**Planning Case #:** Design Study 22287

**Project Description:** Authorizes the repair roof eave, fascia, and reroofing, replace a portion of the existing siding, fencing, and trellis, convert a patio into PT wood decking, replace fixtures, and the removal of gravel in the northwest corner of the lot, and associated site improvements.

# AN EXTERIOR & INTERIOR RENOVATION FOR GREG COSMERO

RE: MBP22-0856, Project Name/Description: ADU, 823 Lydon St., Monterey, CA **Per your checksheet, here is our response for Subject Property:**

**A1.1**

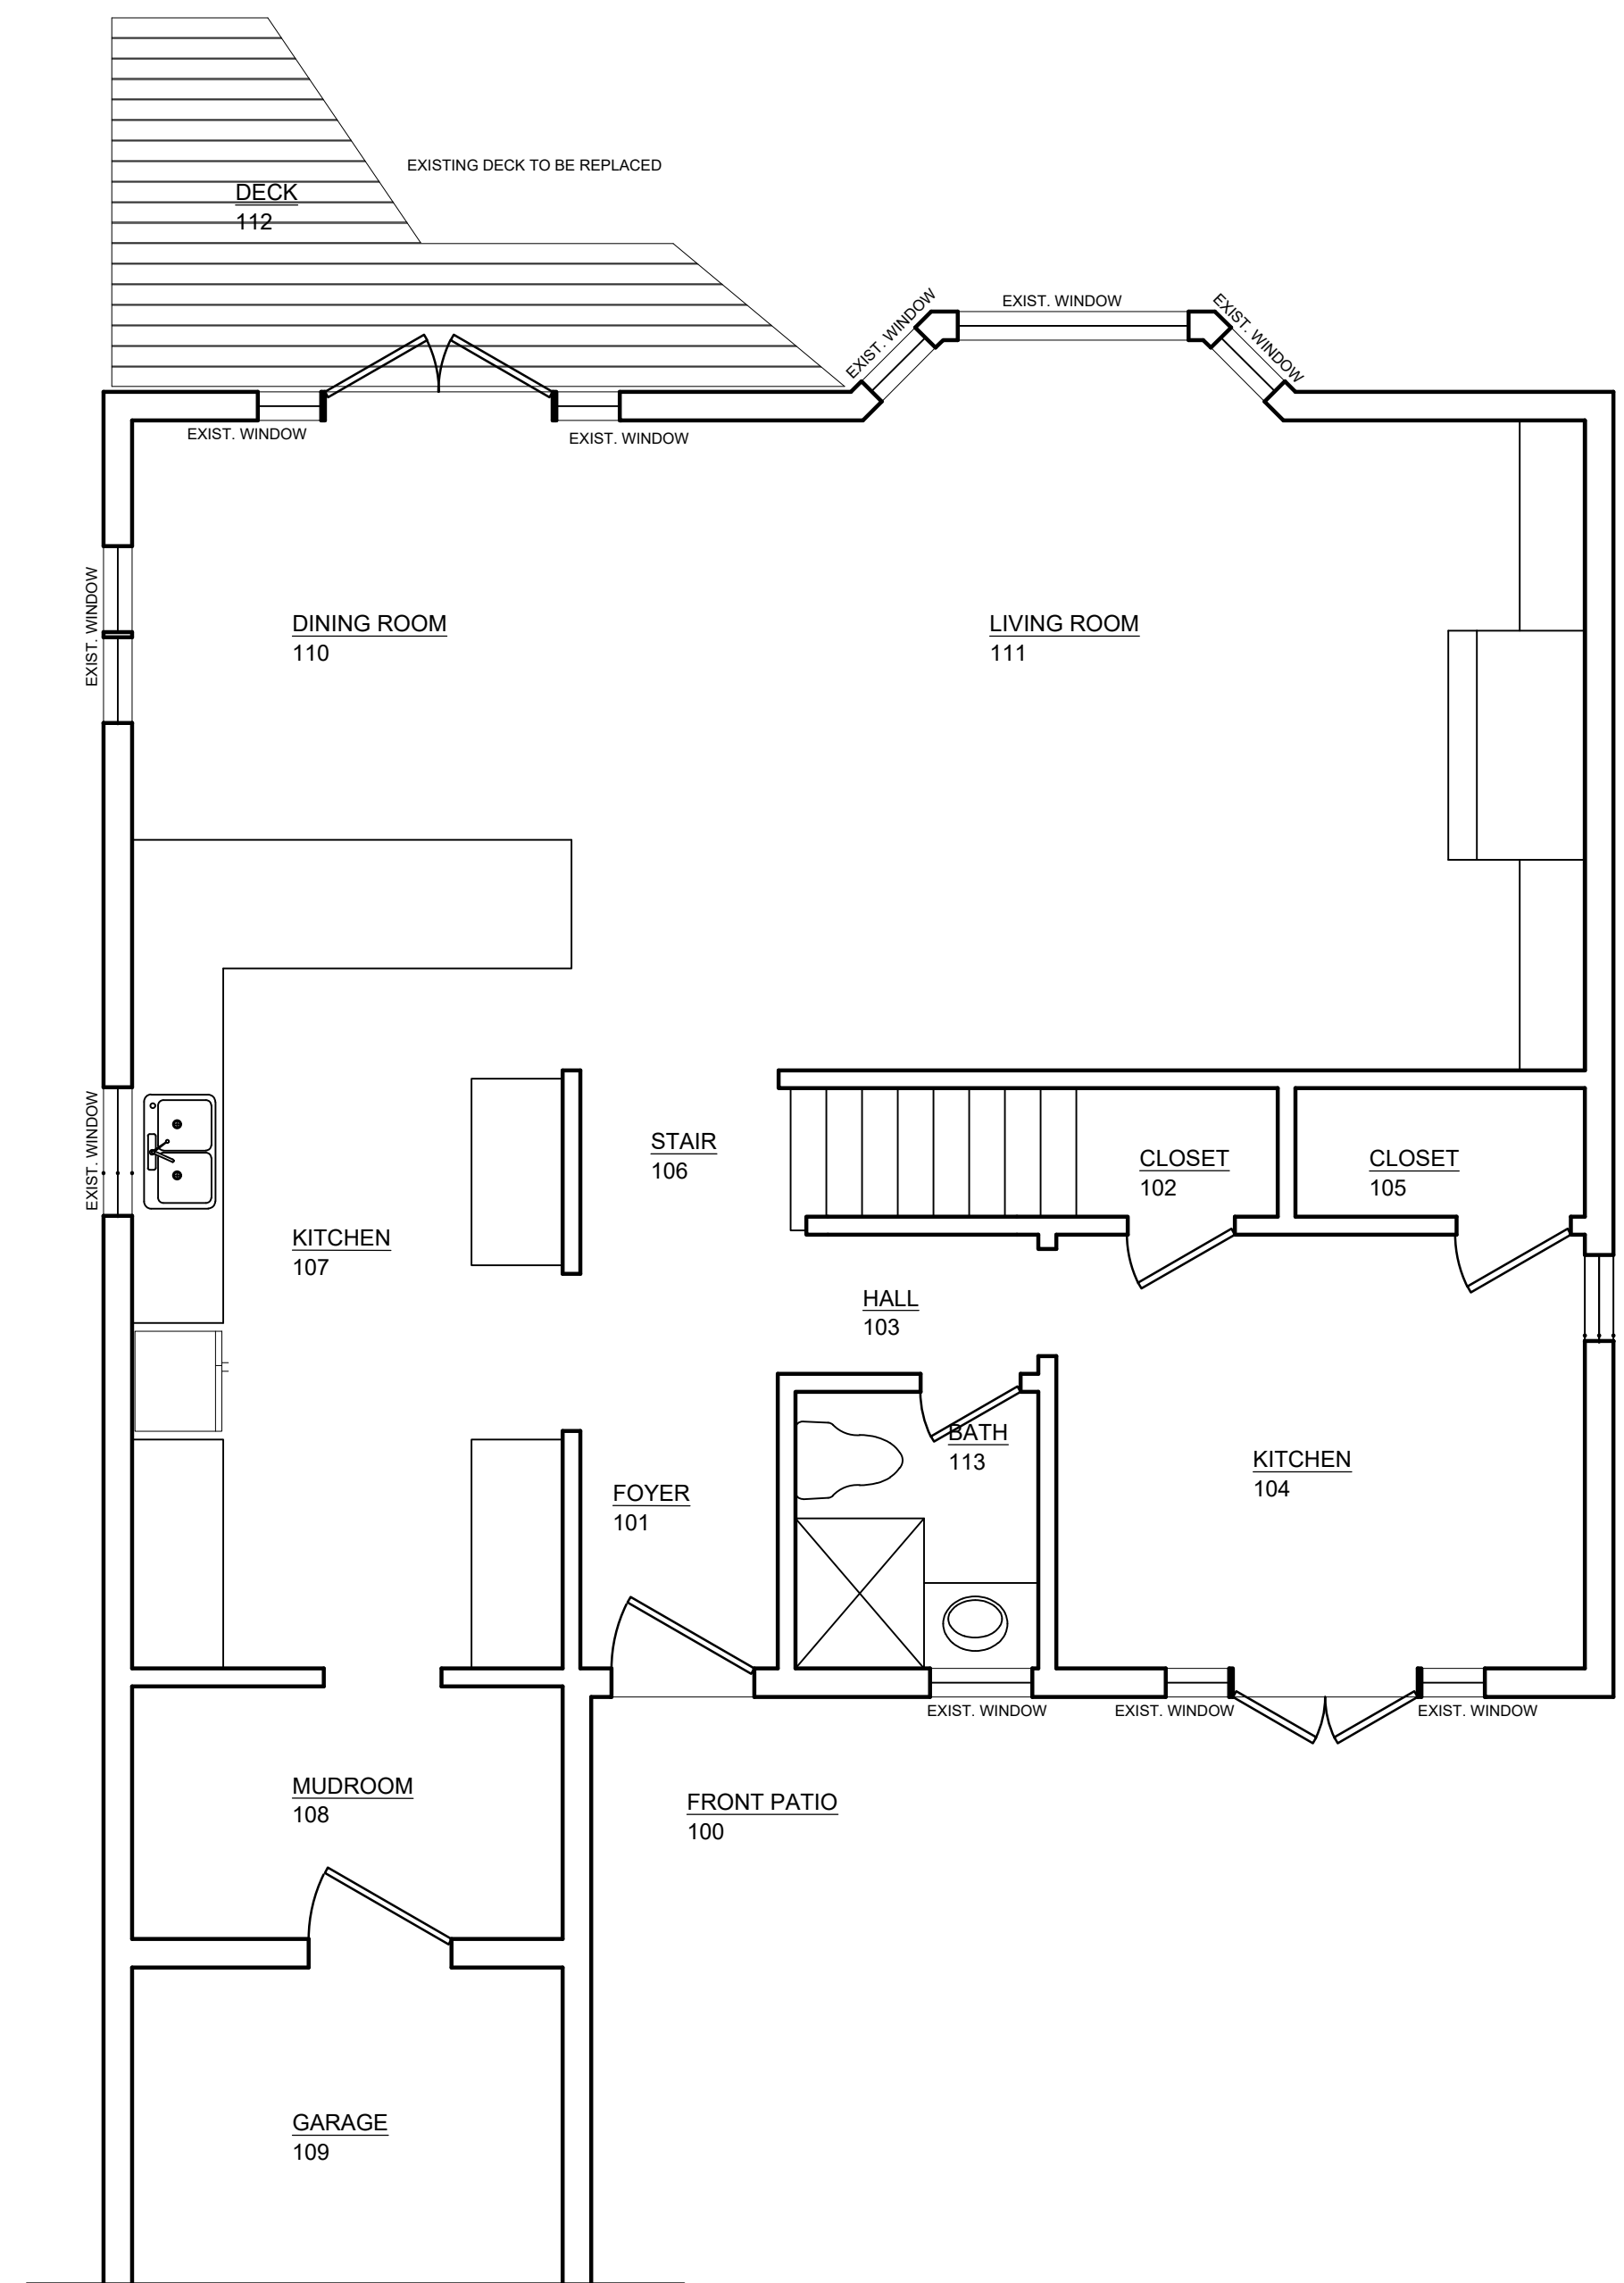
3. Provide a data table showing calculations for existing and proposed site coverage (see sample below) and label all improvements on the site plan, as appropriate. Site coverage is defined as the total ground area of a site occupied by materials or improvements that cover the natural soil but which are outside the perimeter of structures that count as floor area. Site coverage includes:

**Response: Table with areas and labels have been provided on sheet A1.1.**
